Subject: Response to Portion of NRC RAI Letter No. 323 Related to ESBWR Design Certification Application – DCD Tier 2 Section 3.8 – Seismic Category I Structures; RAI Number 3.8-96 S04

**Partial Response to NRC RAI Letter No. 323
Related to ESBWR Design Certification Application¹**

DCD Tier 2 Section 3.8 – Seismic Category I Structures

RAI Number 3.8-96 S04

Figure 3.8-96(1) Horizontal Forces in Sliding Evaluation (Basemat Plan)

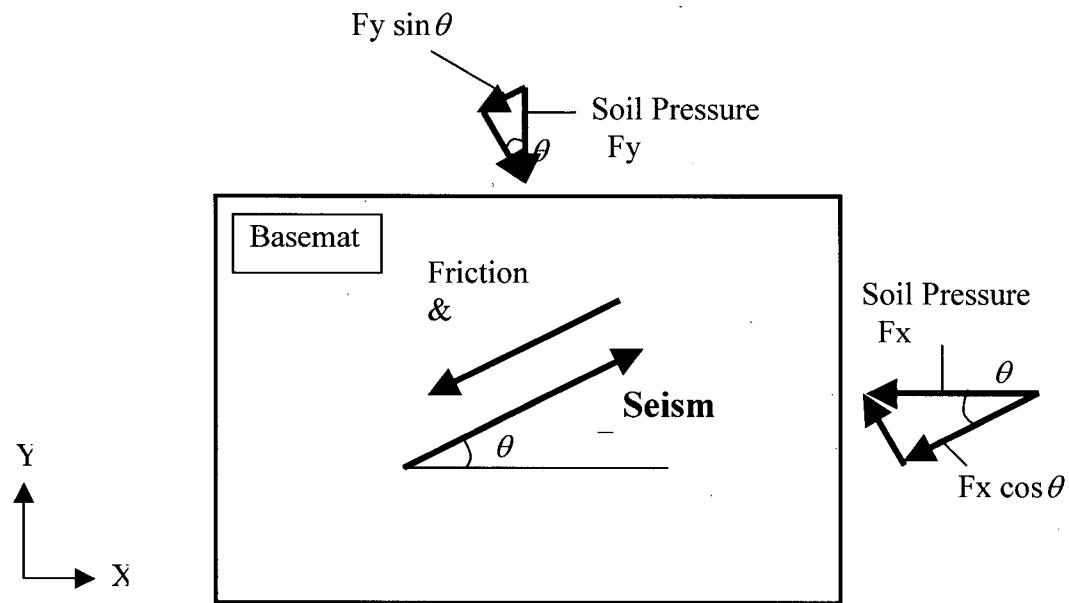
(9) *As noted in the staff's prior assessment of GEH RAI 3.8-96, Supplement 2, response, the traditional method for evaluating the stability (sliding and overturning) of nuclear plant structures in accordance with SRP 3.8 is to perform two separate 2-D evaluations, one for the N-S direction and one for the E-W direction. The minimum vertical downward load (deadweight minus upward buoyancy force minus upward vertical seismic force) is considered separately with the N-S horizontal seismic force and with the E-W horizontal seismic force.*

GEH's proposed application of the 100-40-40 method in this case is not consistent with the staff's acceptance of the method, which as stated in RG 1.92, Rev. 2, applies to combination of individual response components when RSA is used. On this basis, it is not acceptable to the staff. The two approaches described above are acceptable. If GEH chooses to apply an alternate method, then it will need to submit a comparison to results that would be achieved by either one of the two methods described above.

- (9) Alternate sliding stability is performed for the three dimensional seismic loads in accordance with the 100-40-40 rule.

Applied horizontal seismic forces and sliding resistances are schematically shown in Figure 3.8-96(1). Among the resistances, the basemat bottom friction and cohesion act in the direction of the resultant seismic force and their magnitudes are the same as those in the 2-dimensional evaluation.

Figure 3.8-96(2) Shear Key Configuration for the RB/FB Structure

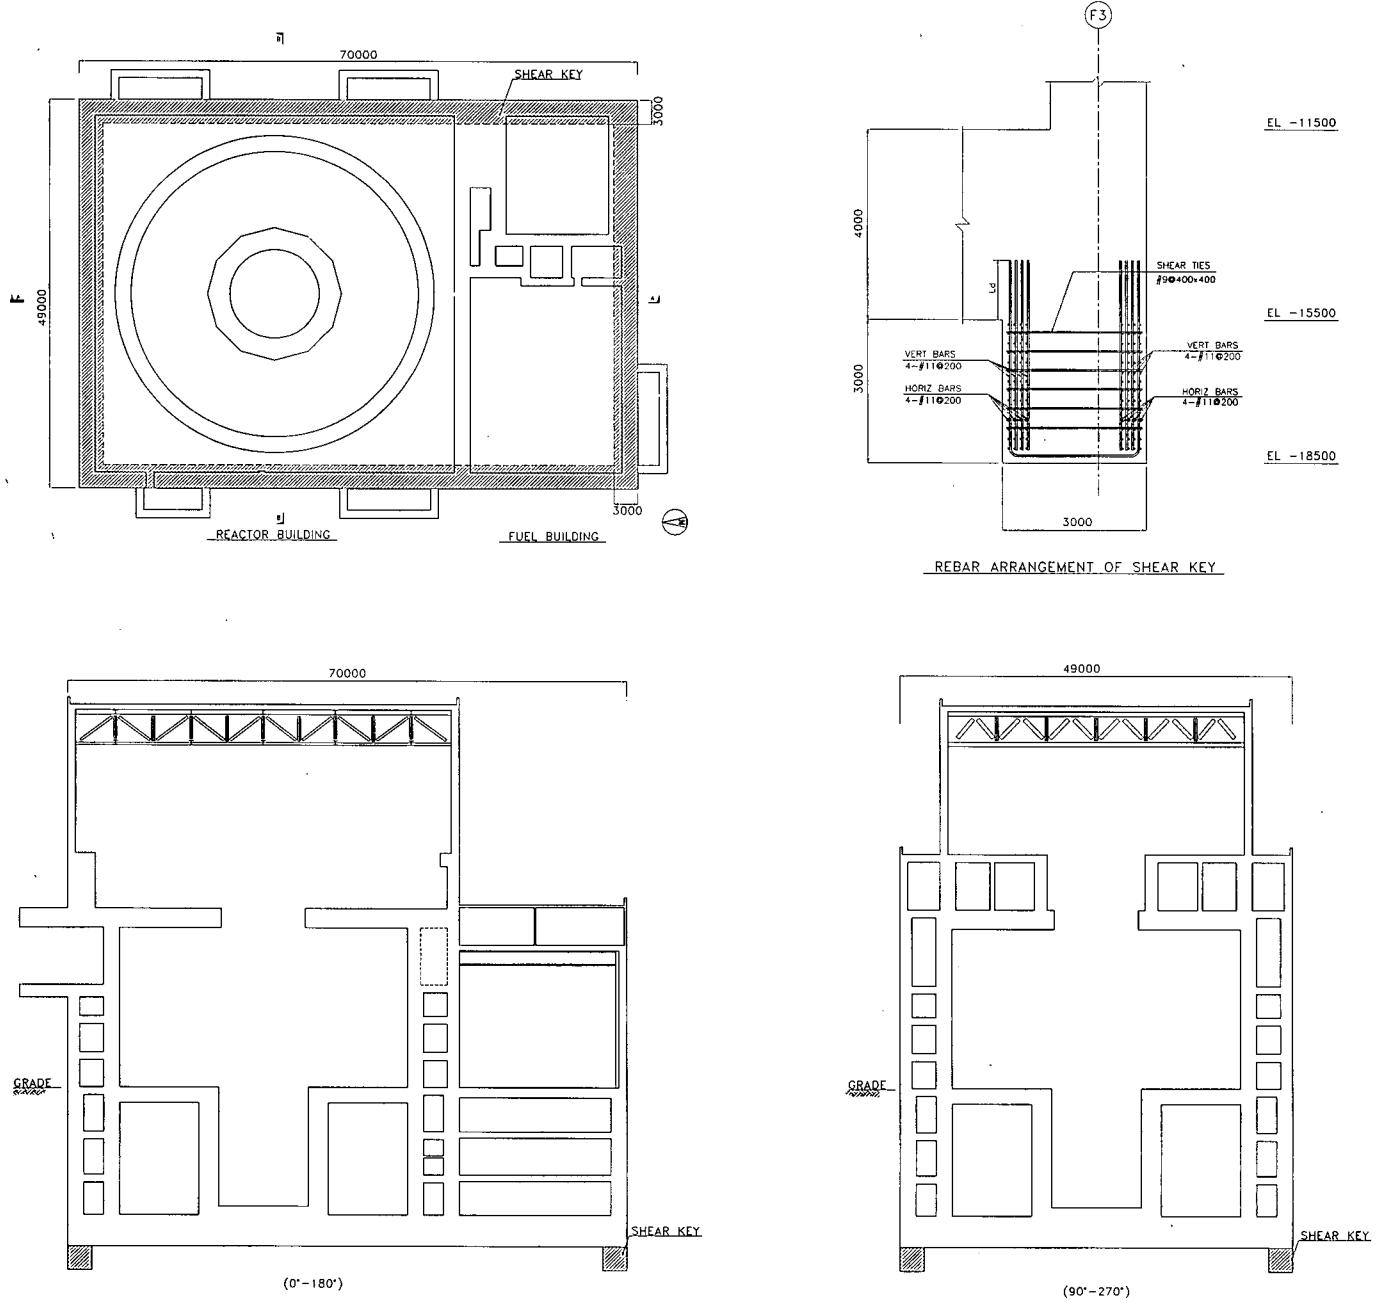
- C) *In Item (9) (pages 22 through 26 of 27), a description of the revised sliding evaluation is presented. This new calculation considers the static coefficient of friction beneath the basemat and on the side walls, passive soil pressures, and at rest soil pressures. As indicated in the prior revision to this RAI, the use of these terms should be based on a consistent set of expected deformations. For example, to develop the full passive pressure capability of the soil implies that sufficient*

foundation deformation occurs. This may not be consistent with the use of the full static coefficient of friction. Therefore, provide detailed information which demonstrates that the individual forces used in the stability calculations are calculated in a consistent manner for the assumed foundation displacements.

The shear key configuration is shown in Figure 3.8-96(2). The reinforcement in the shear key is determined to resist full capacity of the passive pressure less the active pressure.

Figure 3.8-96(4) Coefficient as a Function of Poisson's Ratio

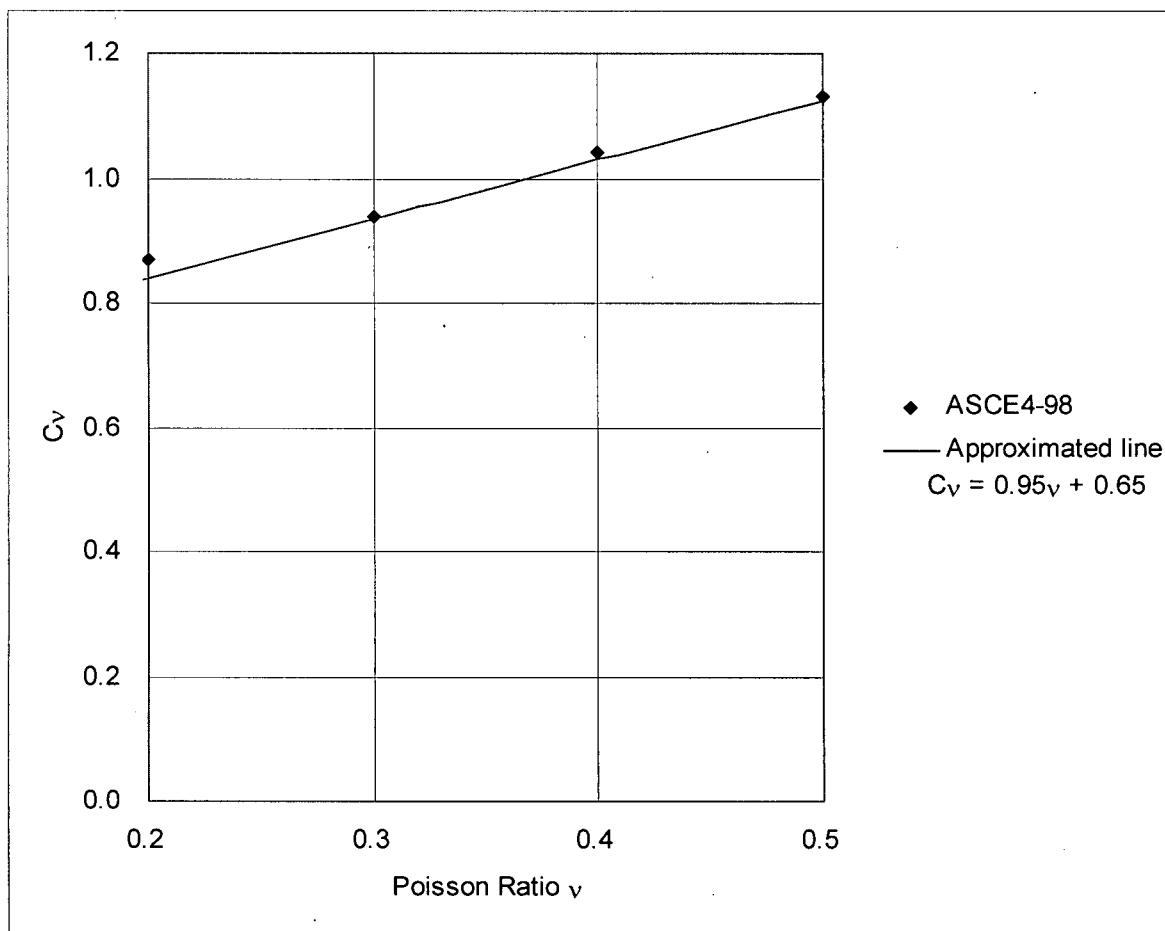
In the same section, GEH also provides the following recommendation: "To ensure the wall design seismic lateral pressures induced from backfill are not exceeded, a COL item will be added in DCD Tier 2 Table 2.0-1 to limit the product of peak ground acceleration (a) of the site-specific Foundation Input Response Spectra (FIRS) in g's, Poisson's ratio (v) and density (γ) as follows: $a (0.95v + 0.65) \gamma$: 1220 kg/m³ (76 lbf/ft³) maximum." Provide an explanation and the basis for this recommendation.

The seismic lateral pressure limit, $\alpha (0.95v + 0.65) \gamma$, is derived from the resultant force F_r equation in ASCE 4-98, Figure 3.5-2, as follows:

C_v : coefficient as a function of Poisson's ratio, v . A numerical analysis of this equation shows that C_v , the coefficient as a function of Poisson's ratio, can be approximated by a straight line, $0.95v + 0.65$, as shown in Figure 3.8-96(4).
